ENGINE - NO.4 BEARING COMPARTMENT TUBES, REPLACEMENT OF OUTER SCAVENGE TUBE ASSEMBLY
SEAL RINGS, SEALING SLEEVE AND TUBE TO BOSS ELBOW - CATEGORY CODE 3 - MOD.ENG-72-0021

V2500-ENG-72-0021

SERVICE BULLETIN

Removal/Installation of the No.4 bearing scavenge tube assembly
Fig.1

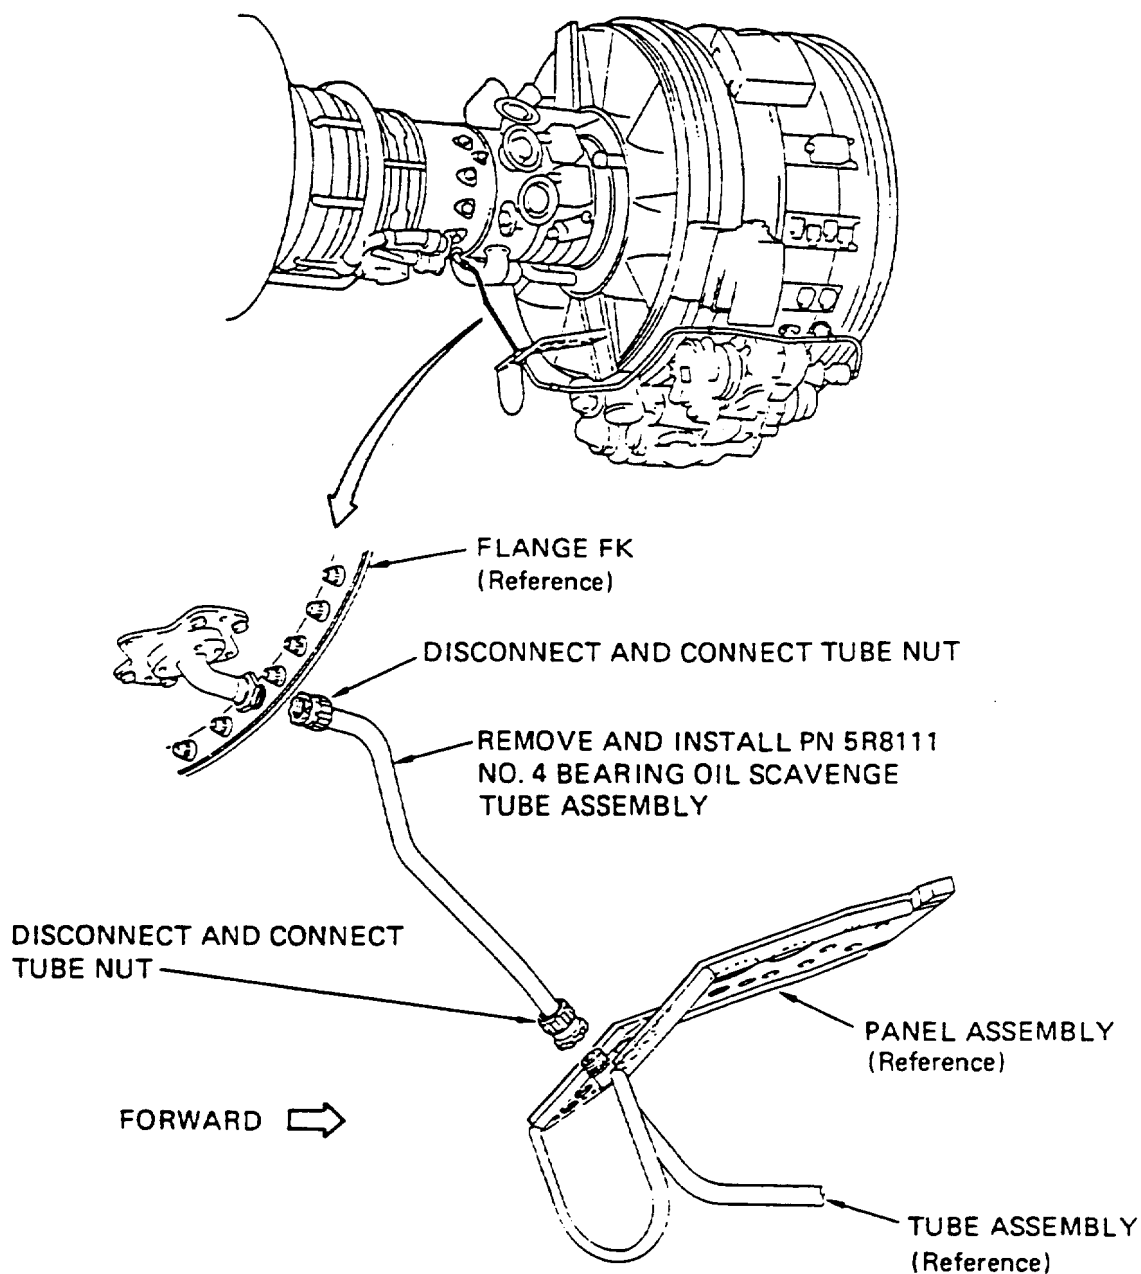
- (a) Remove the lockwire from the Tube Nuts. See Figure 1.
- (b) Disconnect the Tube Nuts which hold the No.4 Bearing Scavenge Tube Assembly with the IAE 1R18002 Wrench.
- (c) Remove the No.4 Bearing Scavenge Tube Assembly.
- (d) Remove the lockwire from the Bolts which hold the Sealing Sleeve to the diffuser case boss. See Figure 2.
- (e) Remove the Sealing Sleeve and Gasket.
- (f) Remove the lockwire from the Bolts which hold the Elbow to the diffuser case boss.
- (g) Remove the Bolts, Elbow, Seal Rings, Gasket and Locks.

- (o) Lock the Bolts with CoMat 02-141 Lockwire.
- (p) Install the No.4 Bearing Scavenge Tube Assembly. See Figure 1.
- (q) While you hold the Adapter with a wrench tighten and Torque the Nut 566 to 611 lbfin. (64 to 69 Nm) with the IAE 1R18002 Wrench. (See Reference (1) 70-41-00 Torque Tightening Technique).

Replacement of the seal rings, sealing sleeve and tube to boss elbow
Fig.2

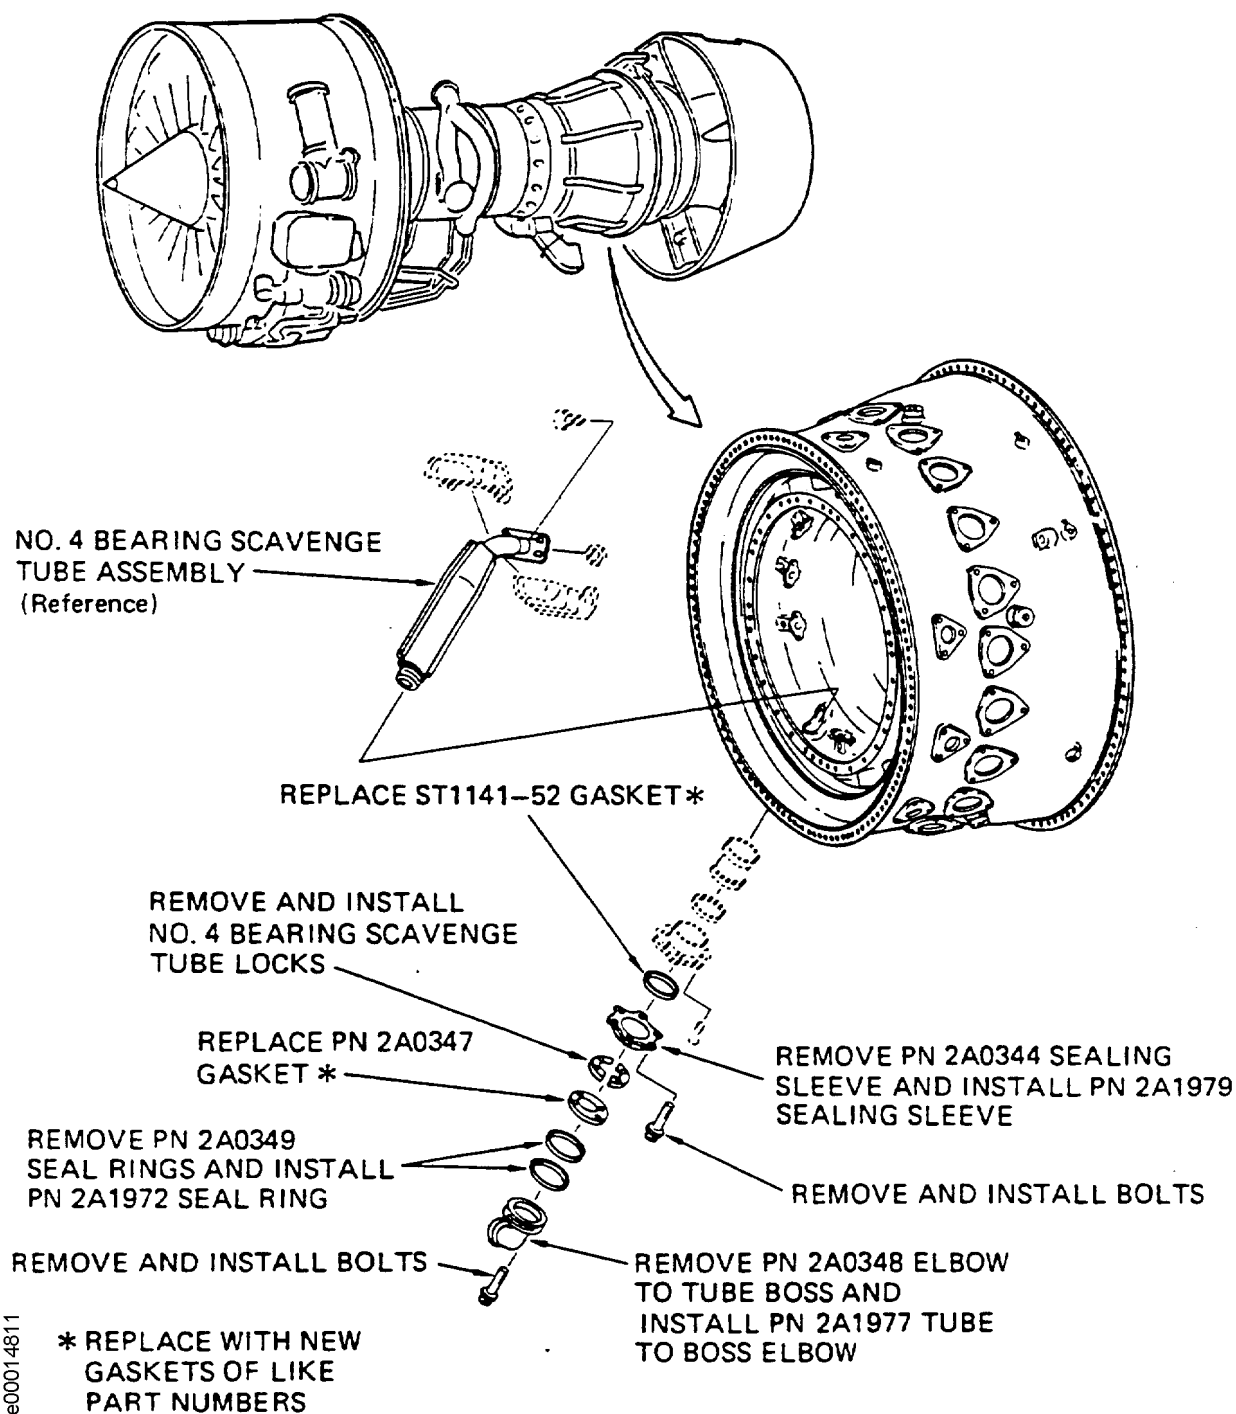
- (1) Eliminate binding between the Scavenge Tube Seal Ring and the expansion joint on the Tube as follows:
 - (a) Provide a new Elbow and Sealing Sleeve which have hard coated sealing surfaces and provision for one rather than two Seal Rings.
 - (b) Provide a new Seal Ring with a smaller outer diameter.

- (a) Install the PN 2A1972 Seal Ring (1 off) into the PN 2A1977 Tube to Boss Elbow (1 off). See Figure 2.
- (b) Lubricate the Bolts (4 off), which will secure the Elbow, with CoMat 10-039 Engine Oil.
- (c) Install the upper and lower Locks (flat face in) to the groove at the end of the No.4 Bearing Scavenge Tube Assembly.
- (d) While you hold the Locks in place install the new PN 2A0347 (1 off) Gasket (raised area in) and the PN 2A1977 Elbow (1 off).
- (e) Install the Bolts (4 off) which hold the Elbow to the Locks.
- (f) Tighten the Bolts with your hand.
- (g) Install a new PN ST 1141-52 Gasket (1 off) in the inner diameter (at the flanged end) of the PN 2A1979 Sealing Sleeve (1 off).
- (h) Hold the Gasket in place with CoMat 01-223 Wax.

- (i) Lubricate the Bolts (6 off), which will secure the Sealing Sleeve, with CoMat 10-039 Engine Oil.
- (j) Install the Sealing Sleeve (large O.D. toward the diffuser) and Gasket, over the Elbow and against the Sealing Sleeve (inner).

- (k) Install the Bolts (6 off) and tighten them with your hand.
- (l) Torque the Bolts (6 off) which attach the Sealing Sleeve to the Diffuser Case Assembly 75 to 85 lbfin (8,474 to 9,604 Nm). (see Reference (1) 70-41-00 Torque Tightening Technique).

- (m) Lock the Bolts with CoMat 02-141 Lockwire.
- (n) Torque the Bolts (4 off) that attach the Elbow to the Scavenge Tube 75 to 85 lbfin (8,474 to 9,604 Nm). (See Reference (1) 70-41-00 Torque Tightening Technique).
